APPEAL SUMMARY

Appeal ID: 27666	Project Address: 6215 NE 34th Ave
Hearing Date: 4/13/22	Appellant Name: Daniel W Keller
Case No.: B-006	Appellant Phone: 2252445900
Appeal Type: Building	Plans Examiner/Inspector: Ken Lee
Project Type: residential	Stories: 2 Occupancy: R-2 Construction Type: V-B
Building/Business Name:	Fire Sprinklers: No
Appeal Involves: Alteration of an existing structure, Correction of a violation	LUR or Permit Application No.: 21-089077-HS
Plan Submitted Option: pdf [File 1] [File 2] [File 3]	Proposed use: SFR and ADU

APPEAL FOR ADJUSTMENT FOR HEAD HEIGHT AT TOILET FIXTURE

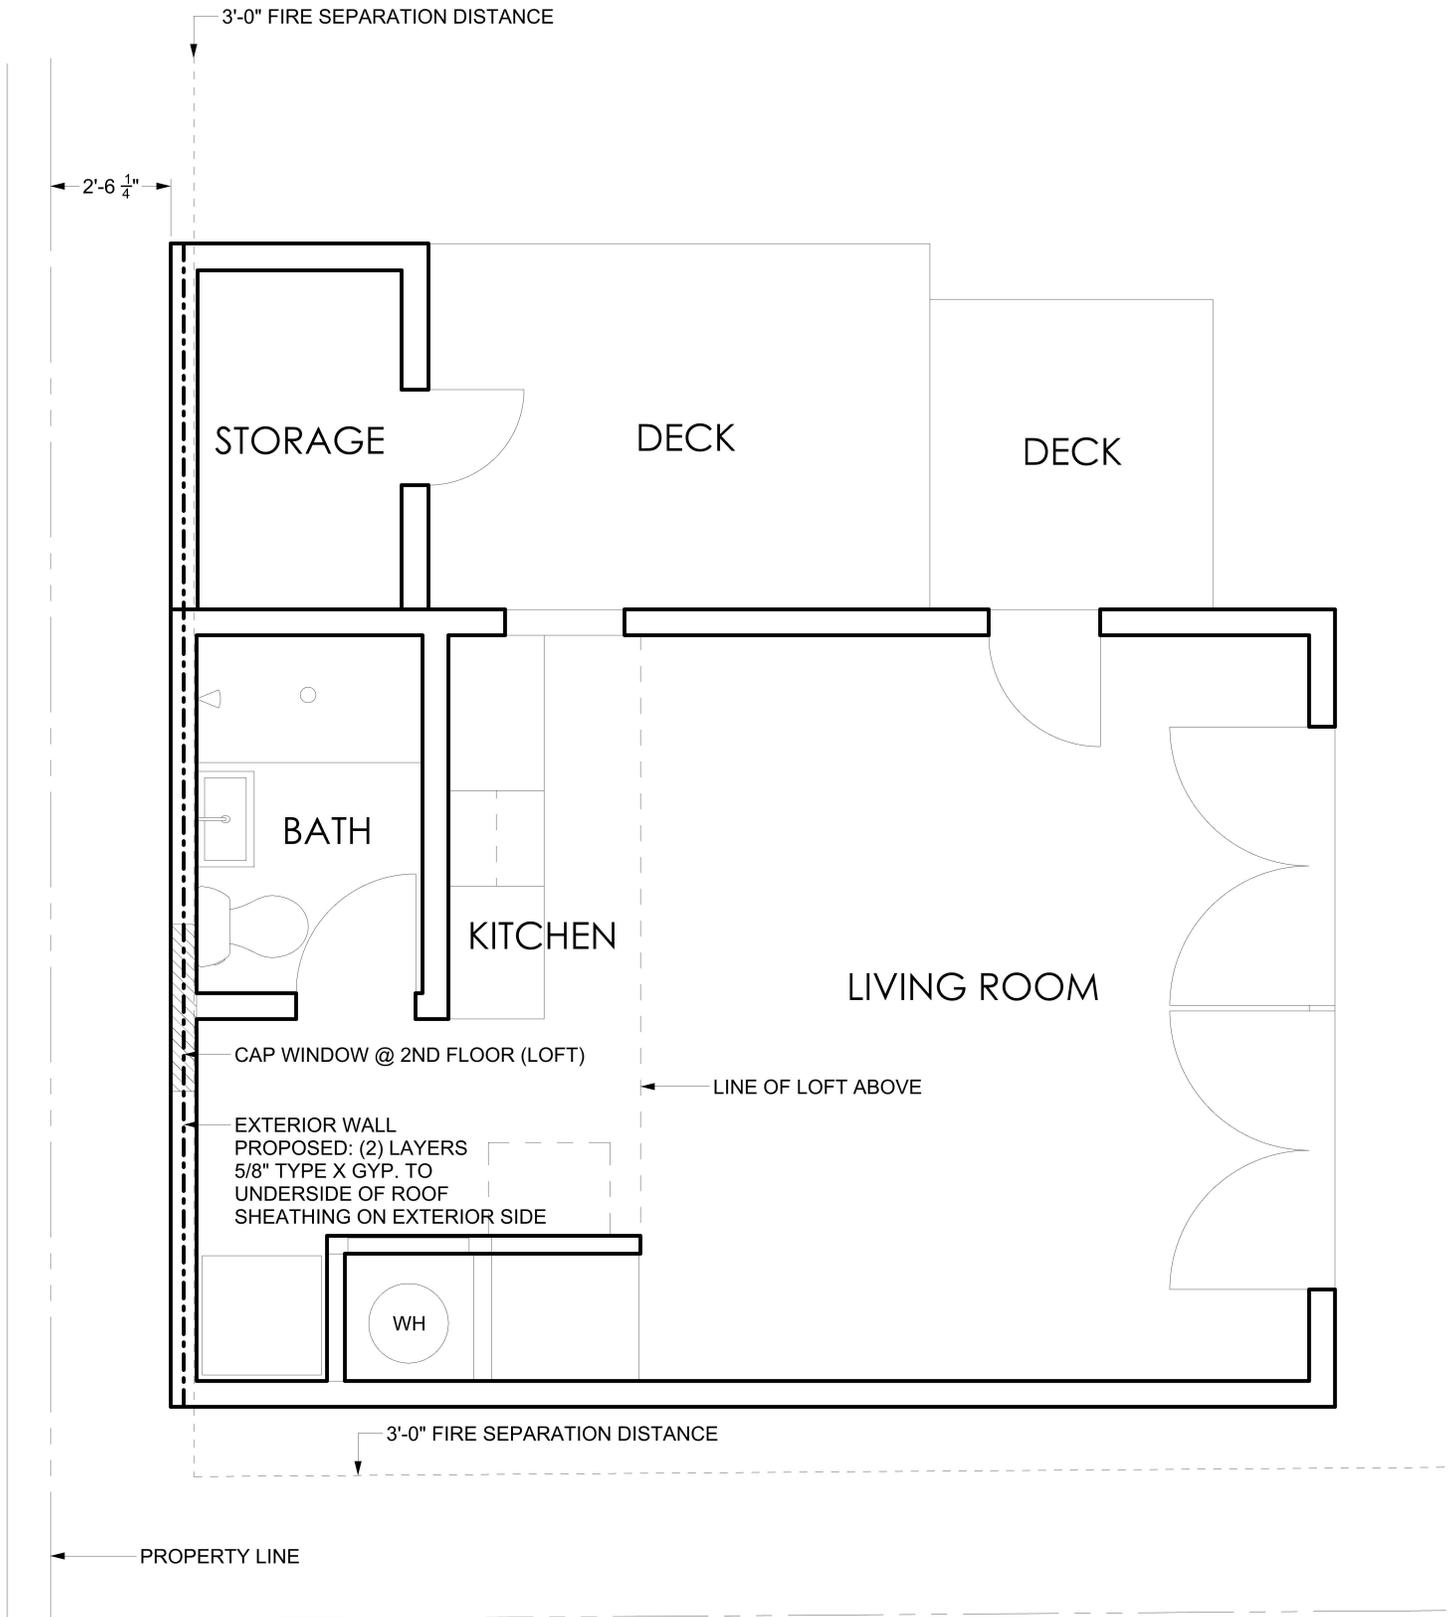
Code Section	R305.1 Minimum Height
Requires	R305.1 - Exception 2: Not more than 75% of floor area of a bathroom or toilet room is permitted to have a sloped ceiling less than 7 ft in height, provided an area of 21 inches by 24 inches in front of toilets and lavatories has a minimum of 6'-4" in height, measured from the finished floor. An area of 24 inches by 30 inches in front of and inside a tub or shower shall have a minimum of 6'-4" in height, measured from the standing surface of the fixture.
Code Modification or Alternate Requested	The intent of the appeal is to add a skylight above the toilet to meet head height requirements in a bathroom with a sloped ceiling.
Proposed Design	<p>The bathroom is located under a sloping roof. Total floor area is 62 SF. Ceiling height at 6'-4" and above equals 35 SF or 56%. Thus, the bathroom meets the dimensional requirements for spaces with sloped ceilings; however, the head height at the toilet does not meet a minimum 6'-4" over the entire required clearance.</p> <p>We propose to install a 30"x 30" skylight over the toilet, sitting on a 5 1/2" curb, thereby adding 11 inches to total head height. The resultant head height on the high side of the required 21"x24" toilet clearance area would be 7'-3" and the low side would be 6'-10".</p>

Reason for alternative	The bathroom is already built and functioning well using existing space and roofline. We are proposing limited alterations to the fixture locations in order to meet 305.1 requirements for sink clearances. However, there is no wall in this space on which both the toilet and sink could fit per 305.1, therefore, the skylight will be necessary to provide equivalent life safety for the necessary head clearance at the toilet.

1. Use of skylight for minimum headroom in bathroom: Granted provided headroom dimensions are verified at time of plan review.
